COMBINATION METER ASSEMBLY

1. Major Difference

Models for U.S.A.

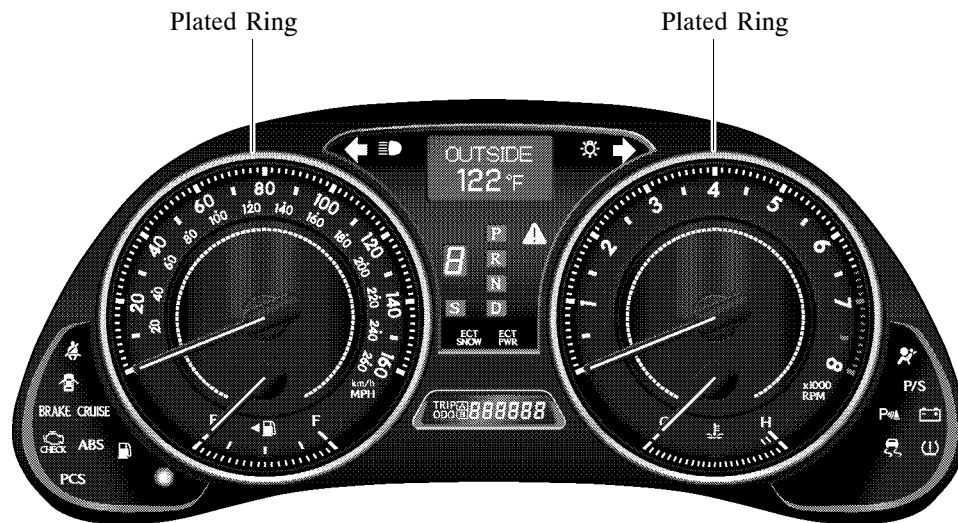
The following design elements and functions of the combination meter assembly have been changed.

Item		Change
Design		<ul style="list-style-type: none"> The panel color has been changed from silver to black. The speedometer and tachometer rings have been plated. The AFS OFF indicator light has been discontinued
Function	Multi-switch Mode Function	The display for the AFS ON/OFF function has been discontinued.
	Warning Mode Function	<ul style="list-style-type: none"> A CHECK HEADLIGHT SYSTEM message has been added. (Models with automatic headlight leveling system) A LOW OIL PRESSURE symbol has been added to the display. (Destination package for Canada)
Buzzer		Hill-start Assist Control warning has been added.
